# Fan Modification

A modification was made to the Detector Head Assembly to avoid oil ingress through the Fan Assembly into the body of the Detector Head.

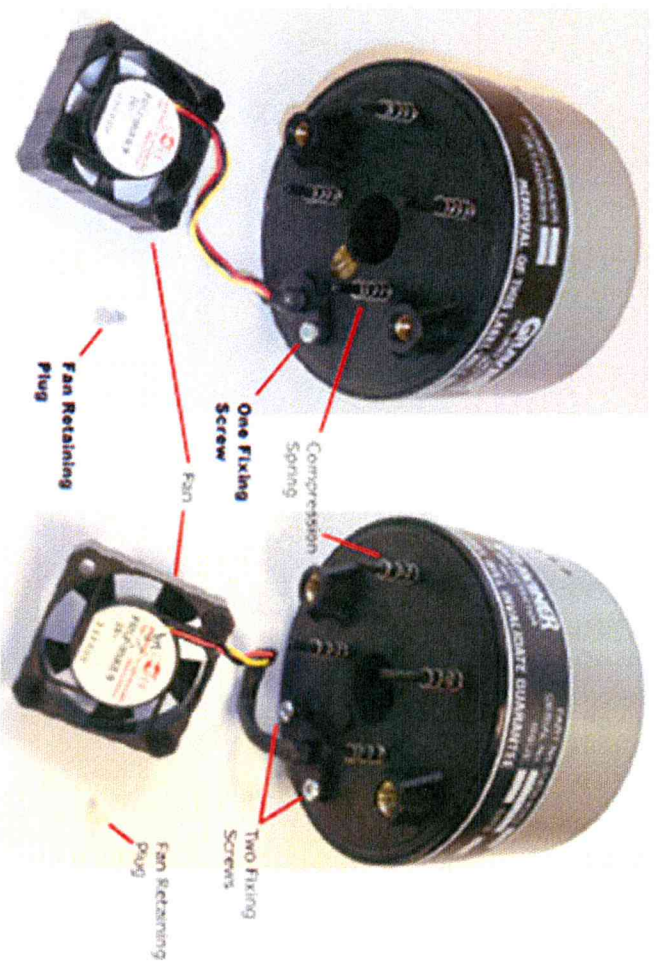
This change was for all new Detector Heads with serial numbers greater than those below:

Since all customer returns have also now been upgraded to current revision, there will be older units in the field fitted with new fans.

Therefore the best way to check which replacement fan the customer needs is to check the number of fixing screws (See images below).

Single Screw Version  
(P/N D5622-005-02)

Two Screw Version  
(P/N 53569-K005)
